NLT Product Change Notice PCN Tracking Number: NLT-PP-6398

Type name
NL8060BC21-11
NL8060BC21-11D
NL8060BC21-11C
NL8060BC21-11F

2. Description of change

4. Product revision

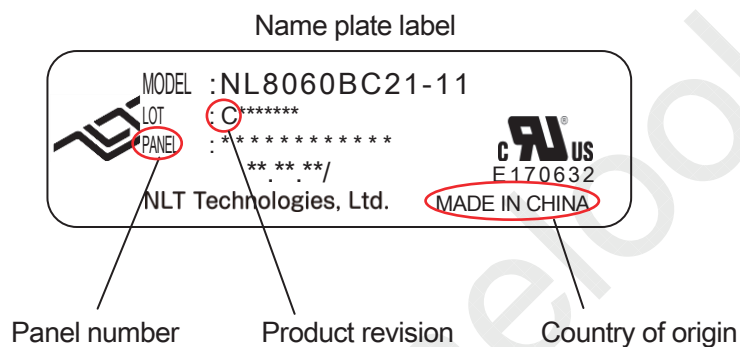
Type name	Current	After change
NL8060BC21-11	B	C
NL8060BC21-11D		
NL8060BC21-11C		
NL8060BC21-11F

6. Internal control label

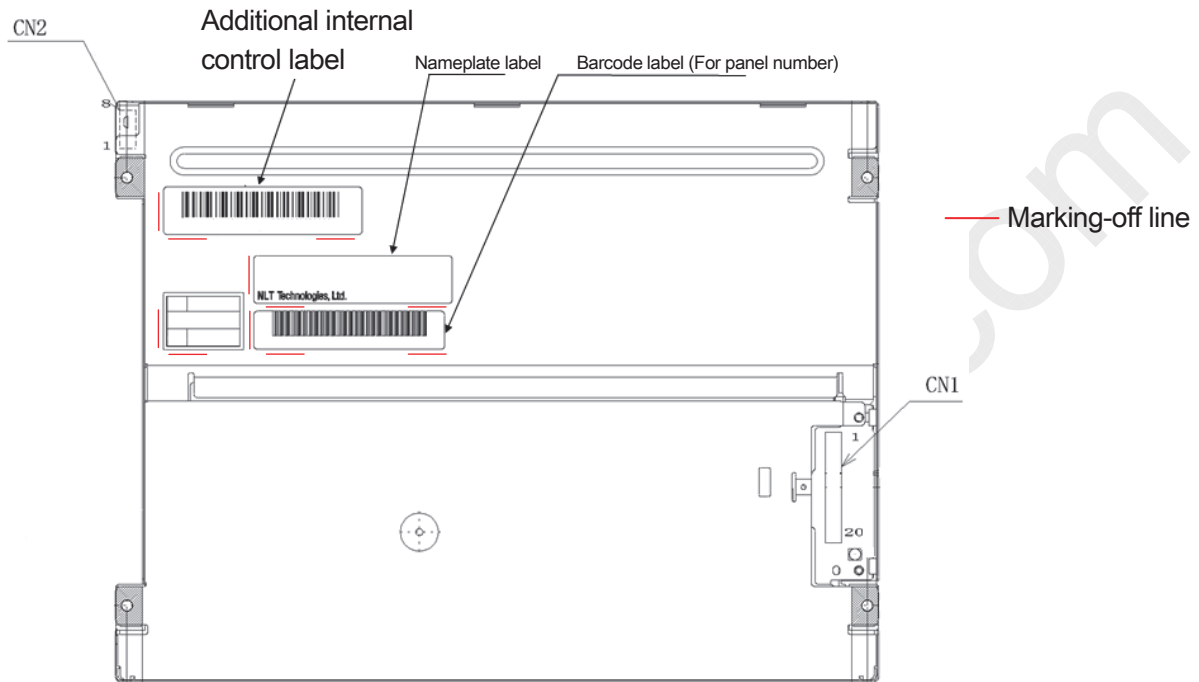
NL8060BC21-11, -11D, -11C, 11F

Back side of the product
